ADDENDUM CC-2

February 2, 2012

PLAYER DEVELOPMENT AREA - UNIVERSITY OF OREGON
CONFORM SET:
Drawings and Specifications for Combined Contract (CC) Dated January 12, 2012

FLOOR PLAN
SCALE: 1/8" = 1'-0"

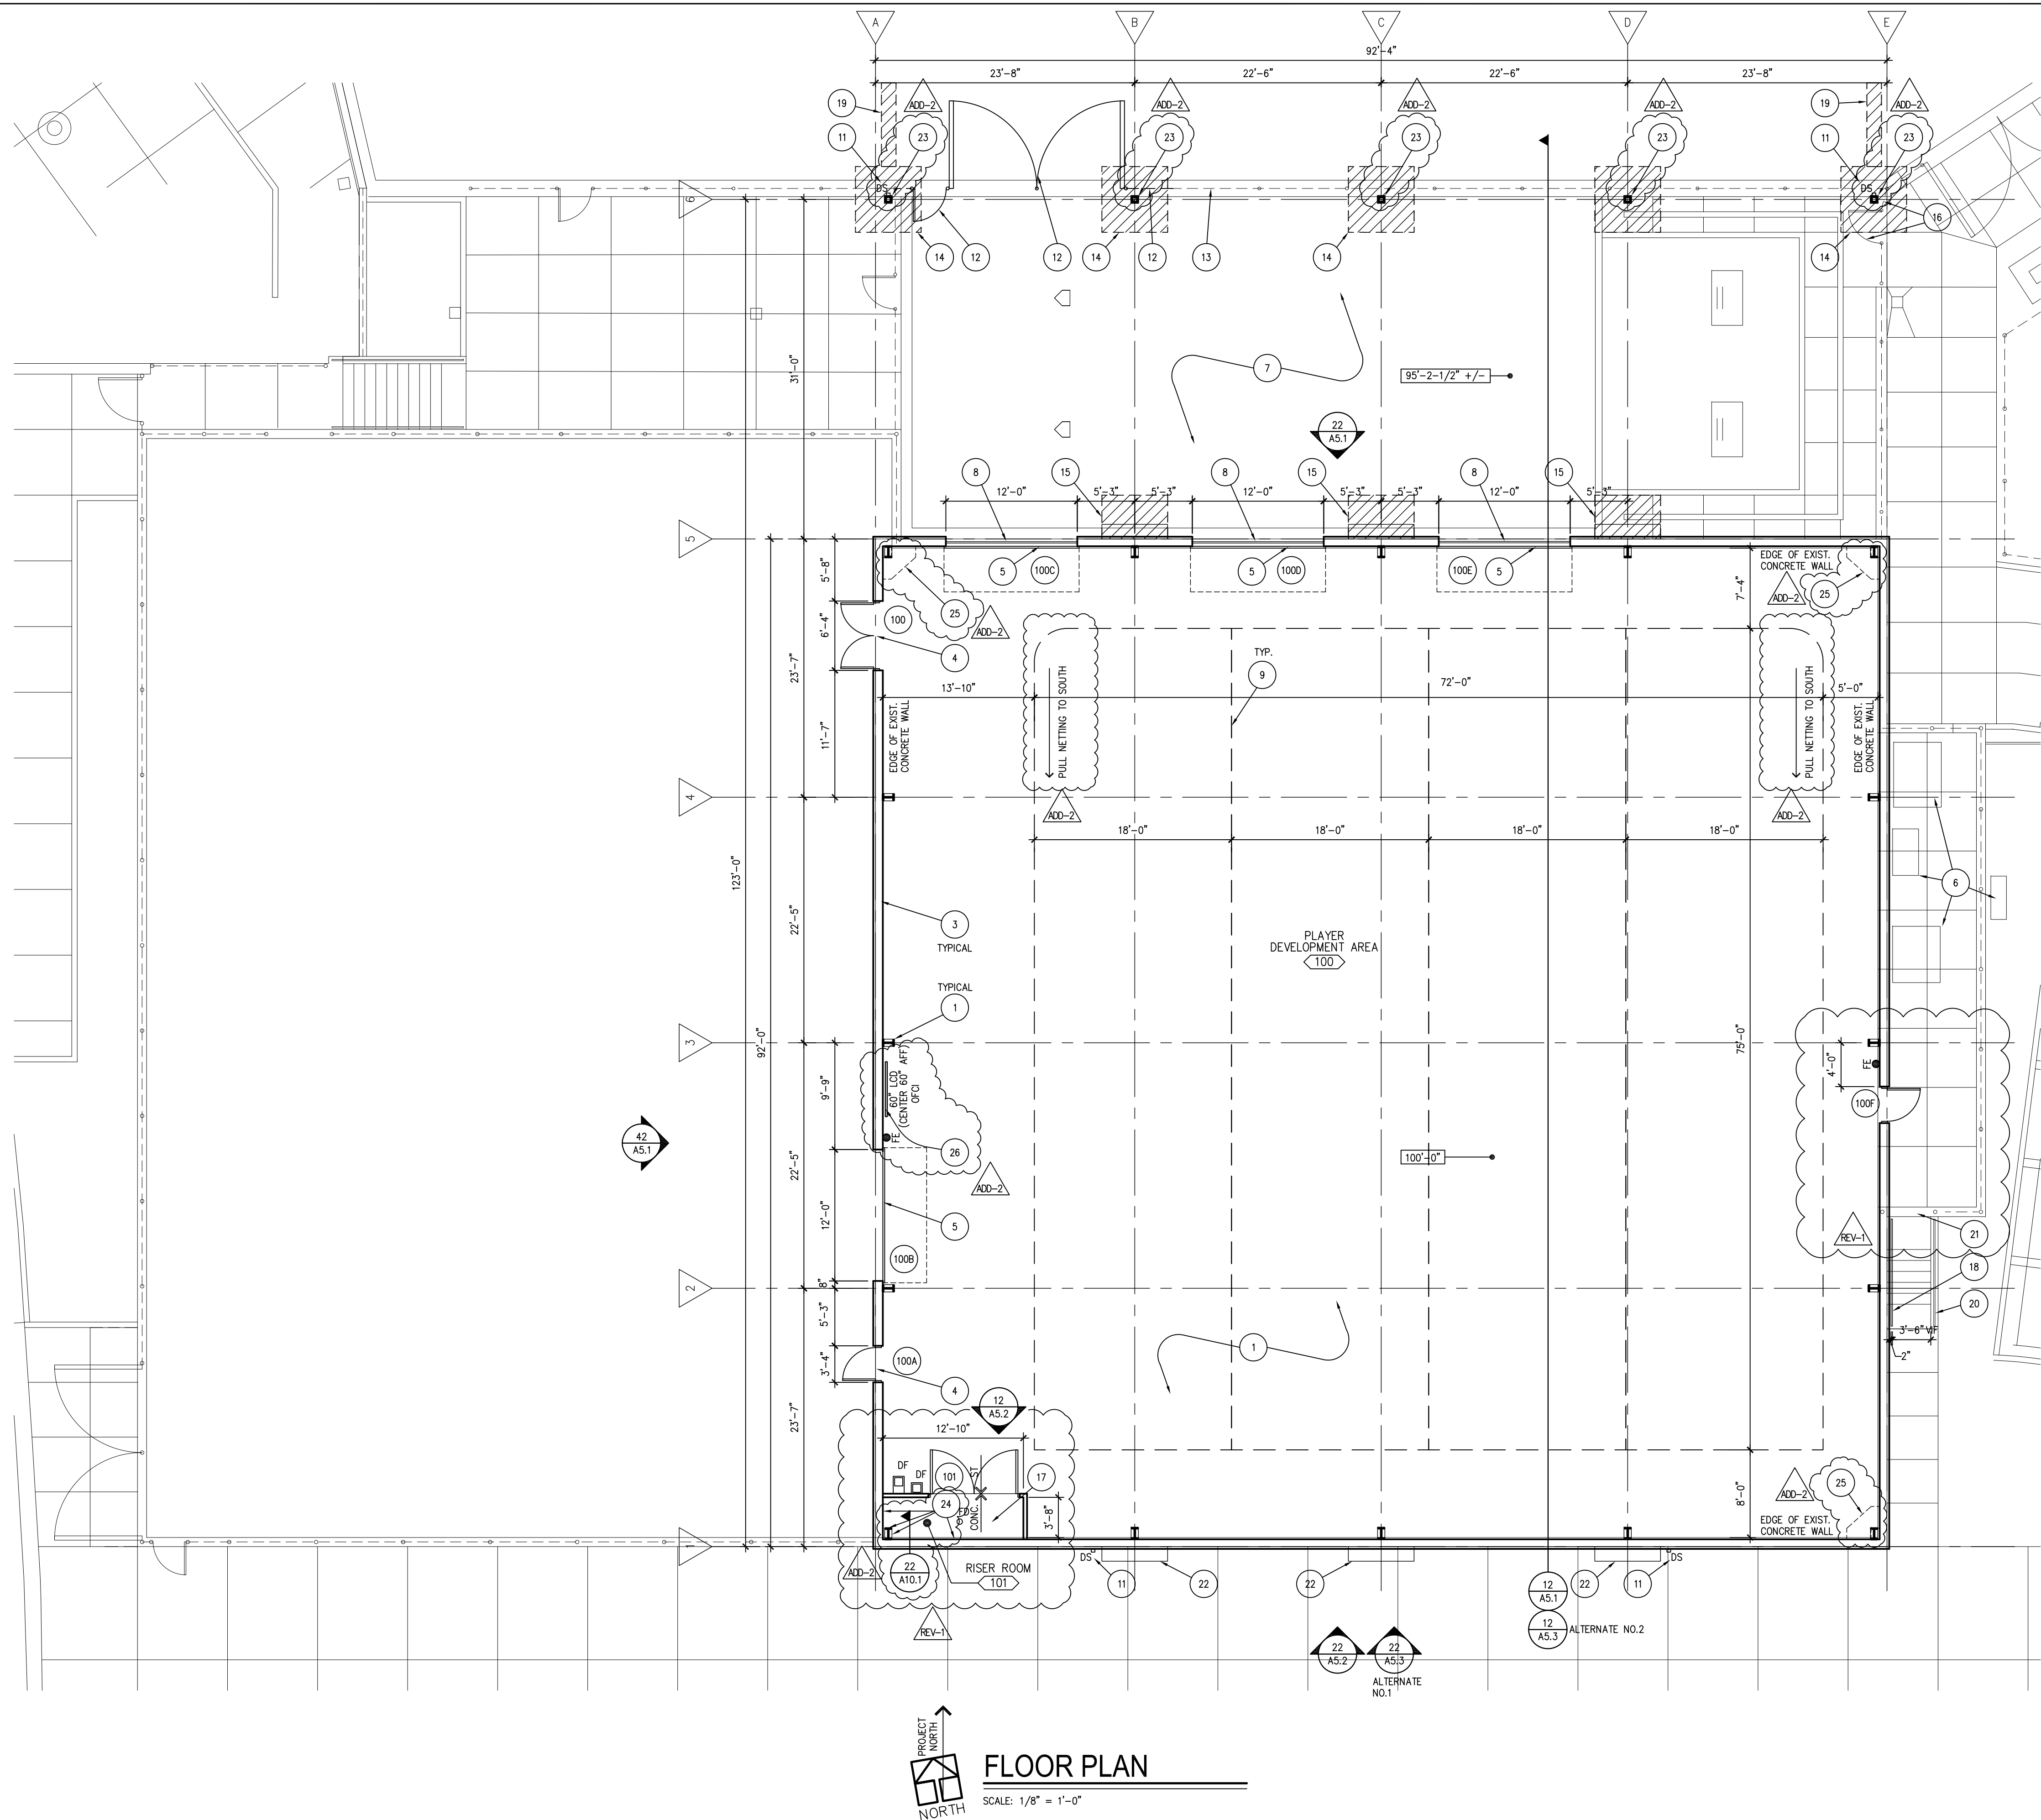
There is a bit of mystery on the scope of the Impact Padding. Could you please list the columns that are reqd to have them? If I had to guess, it would be the 6 exterior canopy columns and the 15 interior columns inside the building (with the exception of the one in the riser room)?

ITEM NO. 39 DRAWING A1.1 – FLOOR PLAN

Answer: Padding for the columns is required only on the exterior columns, which are located in the bull pen area. See revisions to drawings A1.1, A5.1, A5.2, and A5.3 as shown on **Attachment Numbers A4, A6, A7, & A8** to this Addendum.

- E. COLUMN SAFETY PADS ARE REQUIRED FOR OUTDOOR COLUMNS IN BULLPEN AREA AS MARKED ON PLANS AND ELEVATIONS. NO PADS ARE REQUIRED FOR INSIDE THE NEW BUILDING. PER THE ELEVATIONS, THE PADS SHALL WRAP 3 SIDES BEHIND THE PERIMETER FENCE, AND 4 SIDES ABOVE THE PERIMETER FENCE. THE BASIS OF DESIGN FOR THESE PADS IS OAH BASEBALL EQUIPMENT (www.chbaseball.com). PRODUCT REQUIREMENTS ARE:

Attachment No. A5
to ADD-2
Dated: February 2, 2012

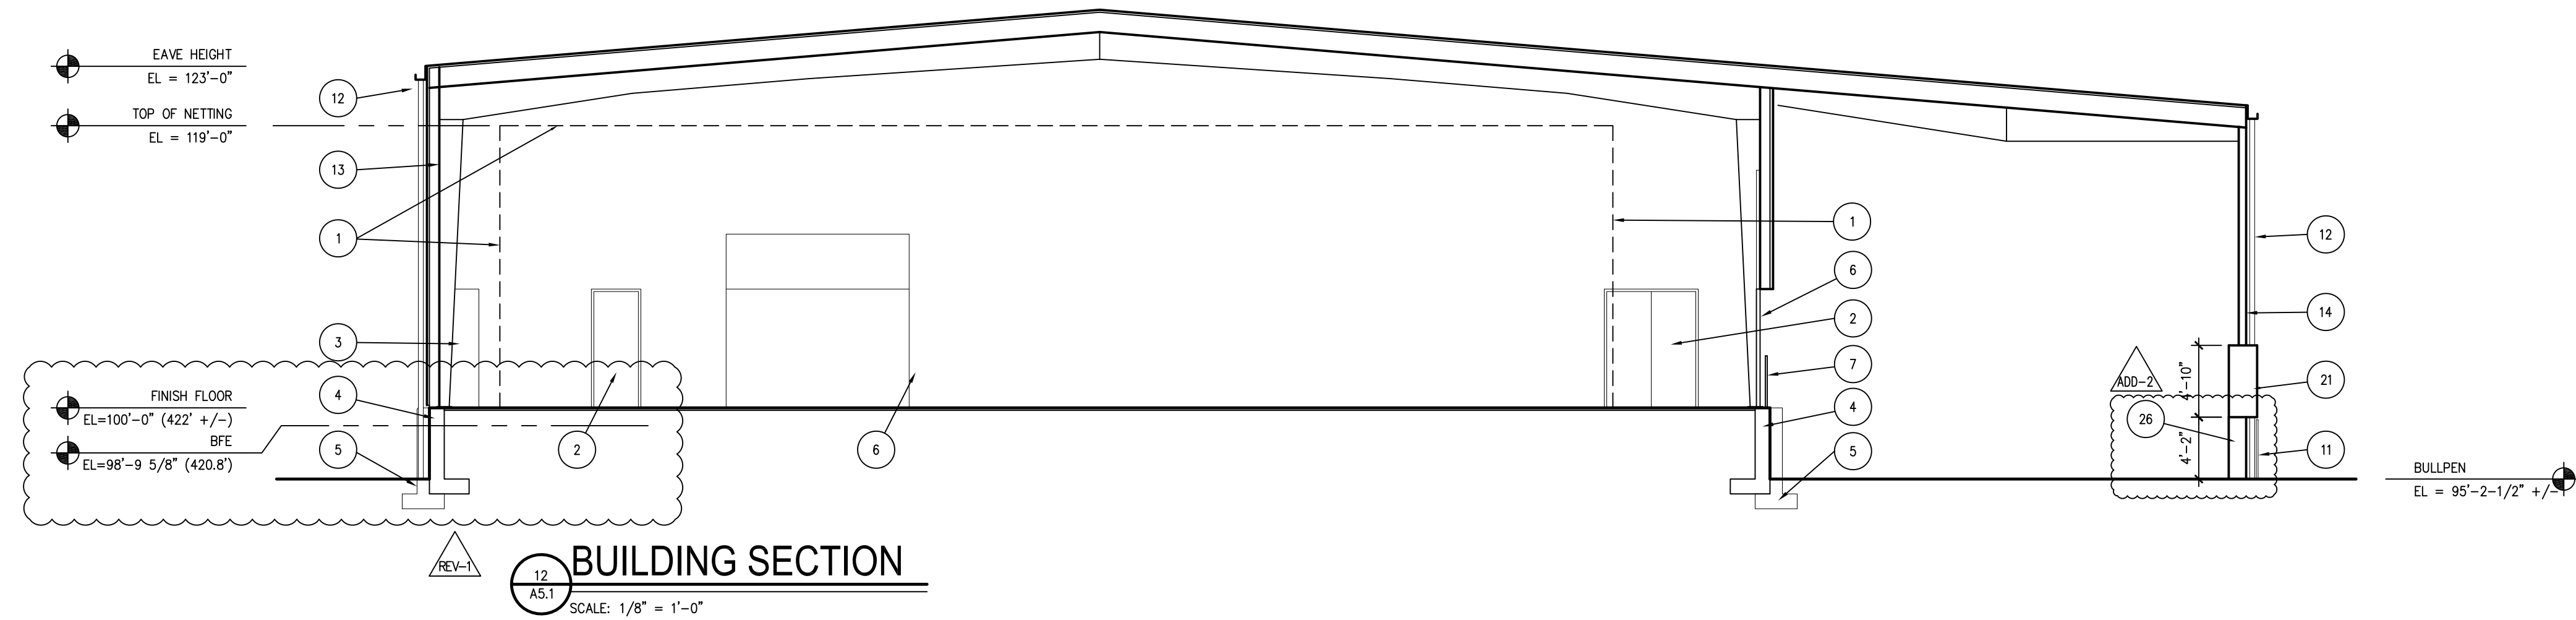
Answer: An insulated single wall curb is required. Its design is part of the metal building deferred submittal. See also revision to Metal Building section, as addressed under the Project Manual heading in this Addendum. The requirement for a double-wall insulated curb has been deleted. The addition of Roof General Notes

provides more clarification. For the latter see revision to A4.1, as shown in **Attachment No. A5** to this Addendum.

ITEM NO. 40 DRAWING A4.1 – ROOF PLAN – BASE BID & ALTERNATE 2

- A. FOR BOTH THE BASE BID AND ALTERNATE 2, THE ROOF PLAN SLOPE IS 1:12.
- B. ALL ROOF CURBS TO BE A MINIMUM OF 8" ABOVE ROOFING LEVELS.
- C. COORDINATE THE SIZE AND LOCATION OF ROOF PENETRATIONS FOR MECHANICAL AND ELECTRICAL EQUIPMENT. REFER TO MECHANICAL AND ELECTRICAL DRAWINGS FOR PENETRATIONS NOT SHOWN ON THIS SHEET.

A5.1
 74-11105-00
 11-04-2011
 12-22-11
 02-02-12 ATTACHMENT NO. A6

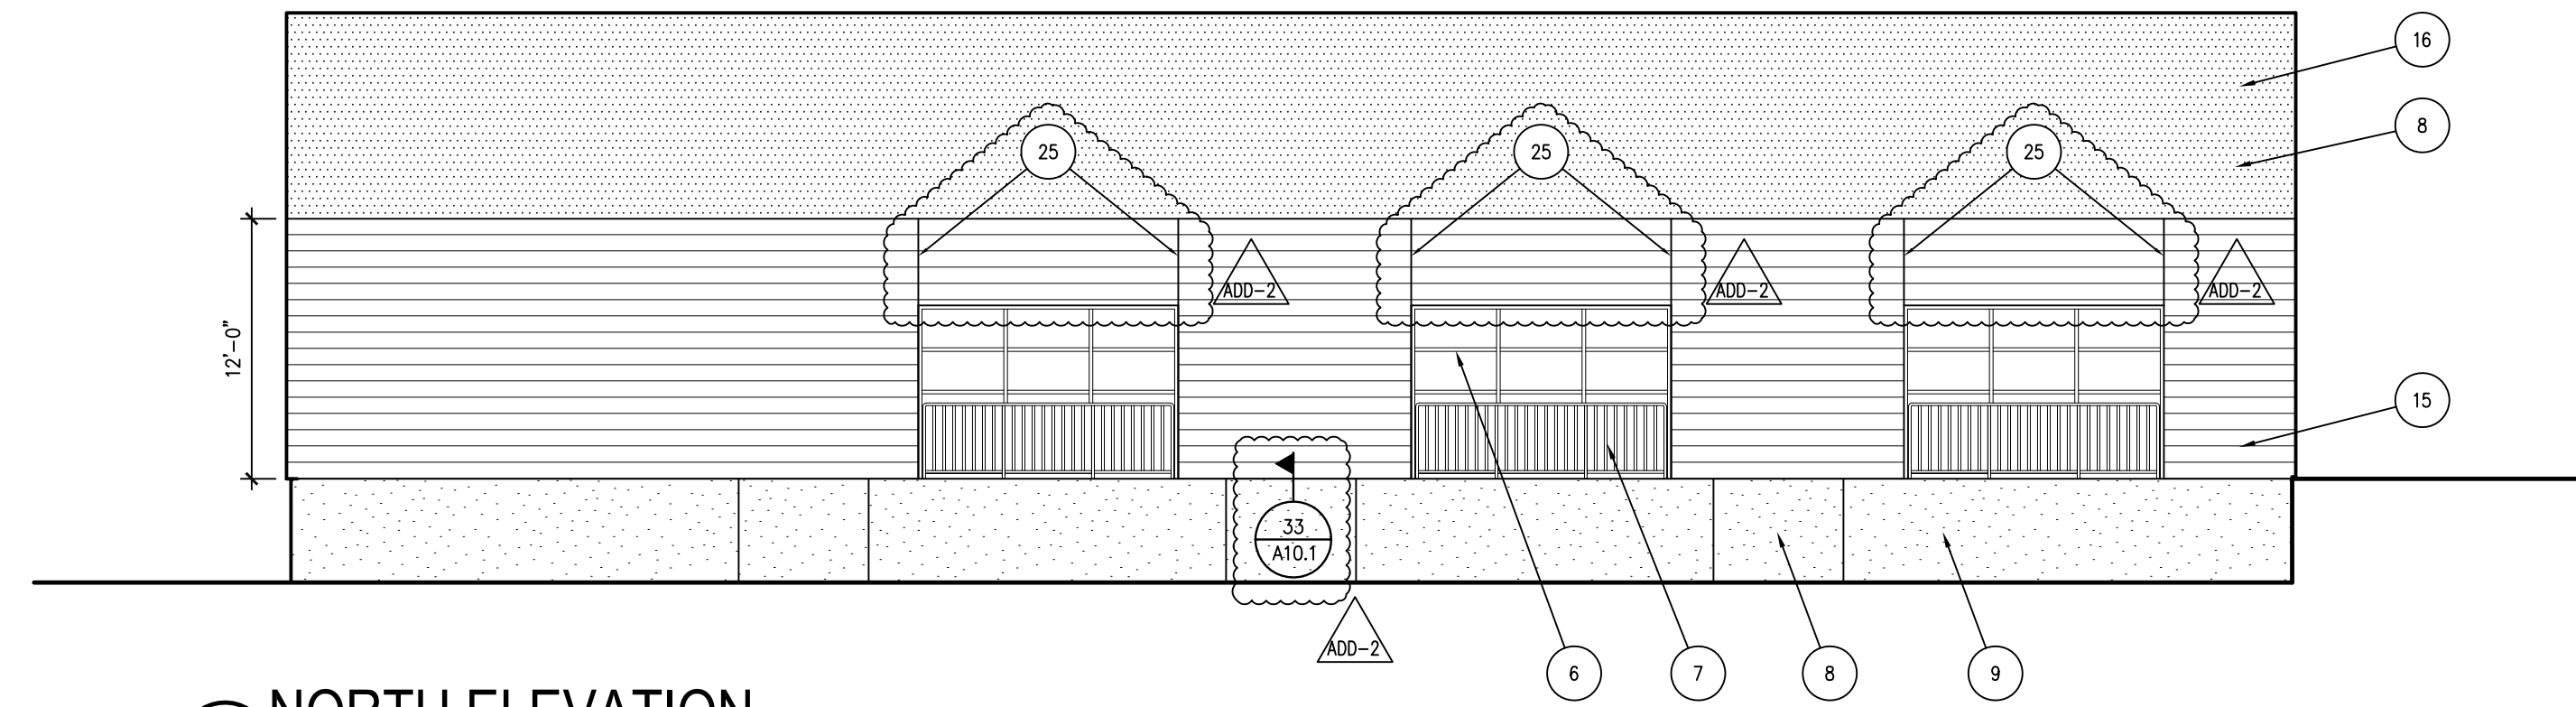
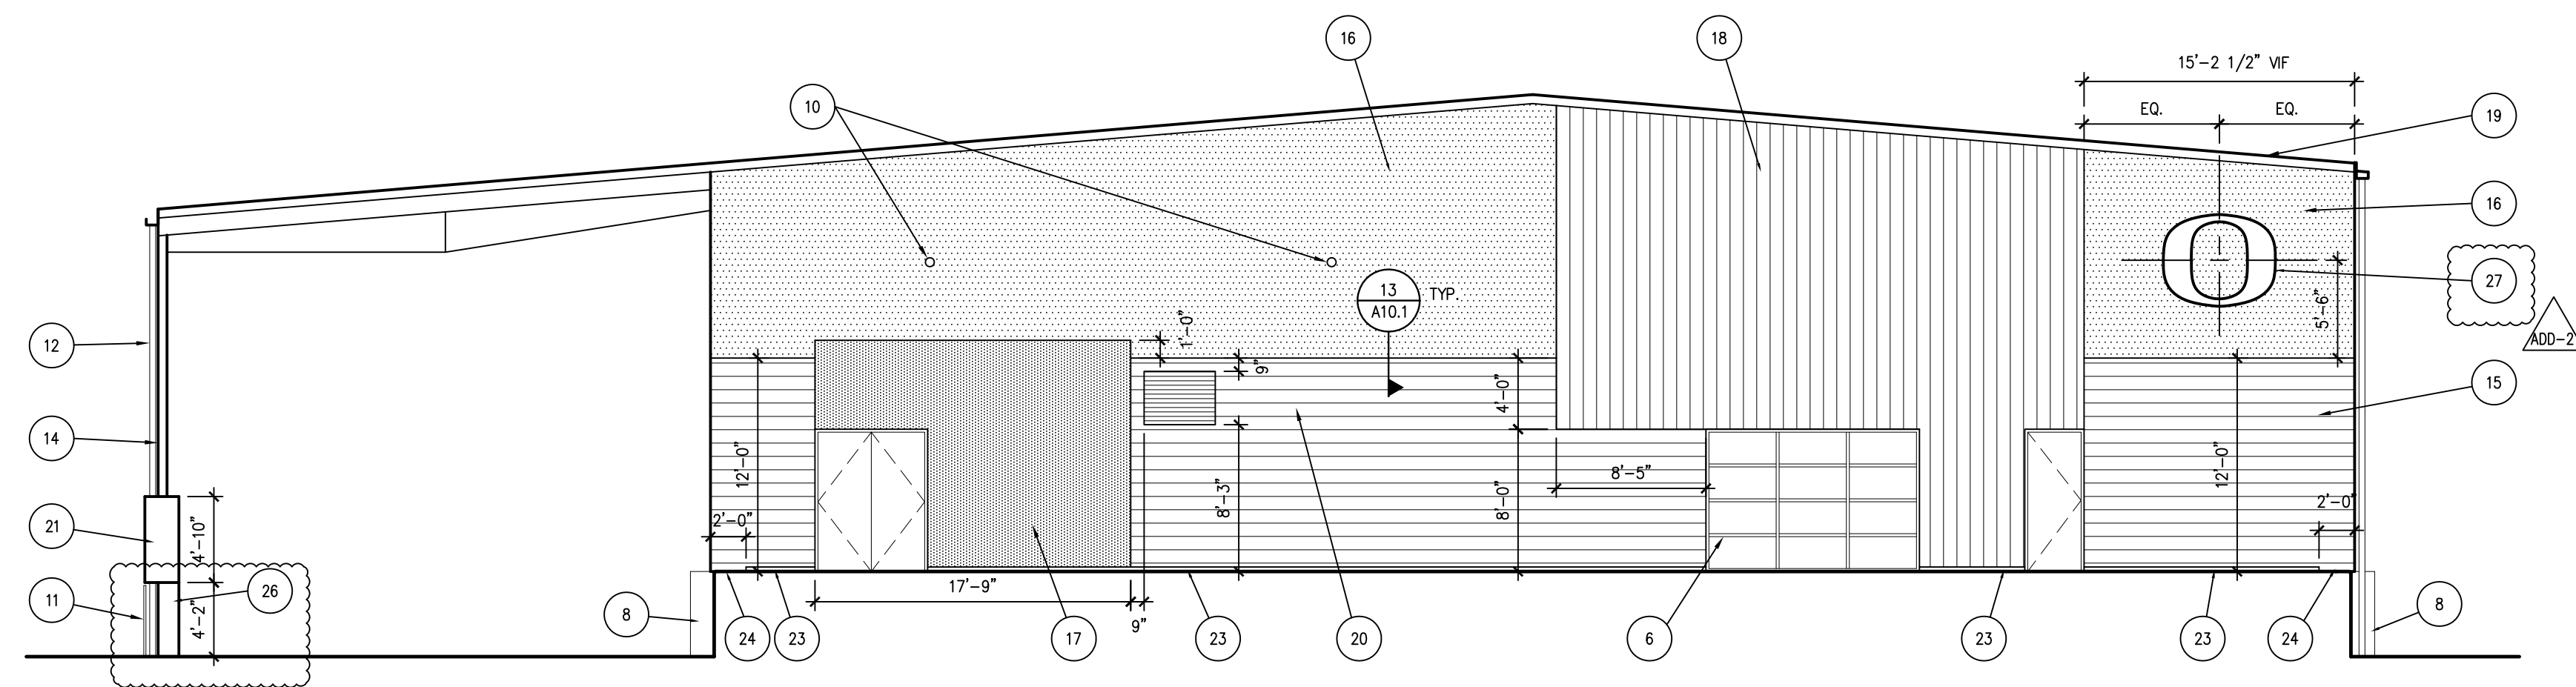
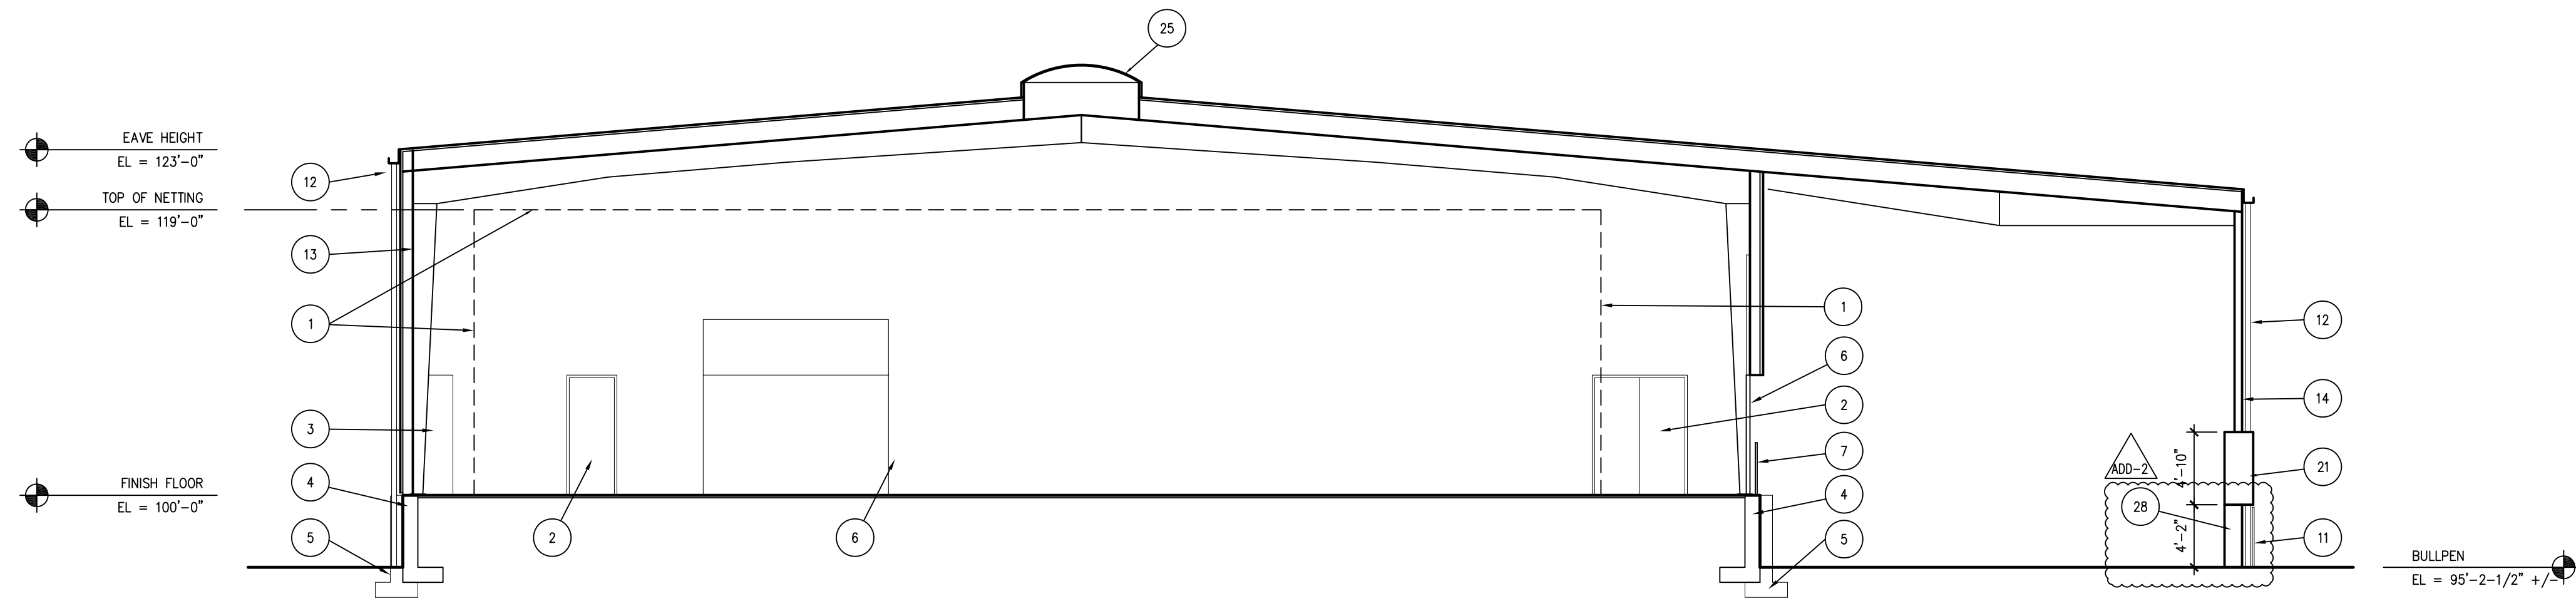
Answer: See revisions to drawings A5.1, A5.2, and A5.3 (**Attachment Numbers A6, A7, & A8** to this Addendum), which now show the vertical joint locations.

ITEM NO. 41 DRAWING A5.1 – BUILDING ELEVATIONS & SECTION
